Urgent Field Safety Notice

Subject: Liko® Multirall™ 200 Q-link strap lock replacement

FSCA-identifier: MOD1322

Type of action: Device Modification

Correct vs incorrect attachment of Q-link strap lock of Multirall 200 to S65 rail carriage hook

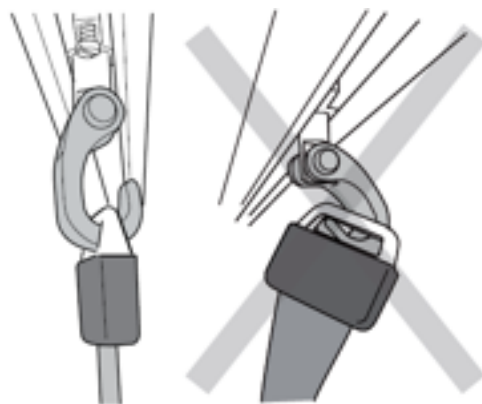
Hillrom continues to receive complaints of incidents where the Multirall Q-link strap lock has not been correctly attached to the S65 rail carriage hook by user (illustrations below). This may lead to the Multirall lift becoming detached from the rail system, potentially resulting in the fall of both the lift motor and the patient. An advisory notice, with reinforcement of the instructions for use was shared with all customers of the Multirall 200 in 2017 (MOD1267), and since then additional complaints of serious incidents due to this use error have been received by Hillrom.

Hillrom will be replacing the Q-link on Multiralls to Q-link II to improve ease of use and mitigate potential risk to patient or caregiver.

The Q-link 2 strap lock design

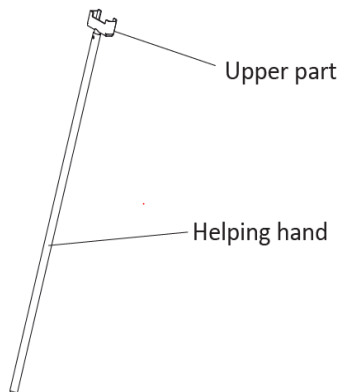
The Q-link II strap lock (illustration below) was introduced on the Multirall overhead lift to resolve ease of use issues with the application of the Q-link strap lock to the S65 carriage

hook, particularly while applying the Q-link strap lock from the ground level with the Extension arm accessory (illustration below). The Q-link II has a larger opening which allows for better visibility while attaching the hook and the rolling feature of the Q-link II strap lock makes it easier to apply on the S65 rail carriage hook.

Extension Belt, adjustable. (3136226, 3136227, 3136228 and 3136229)

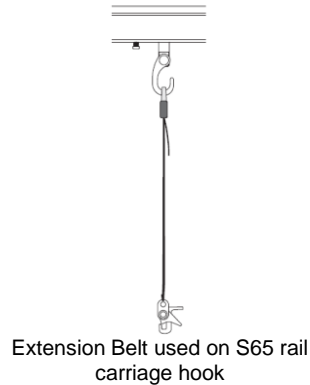
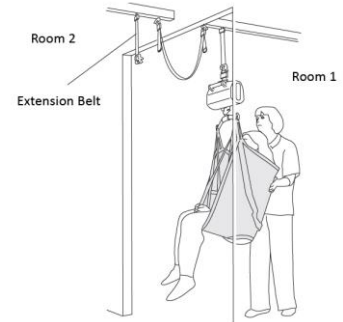
Category B Multirail installations are combined with an **extension belt** (illustrations below)

Once you have identified units affected by this field corrective action and you have returned the response form, you will be contacted by Hillrom or an official Hillrom distributor, to schedule the replacement of the Q-link 1, R2R accessories and extension belts if present in the installations.
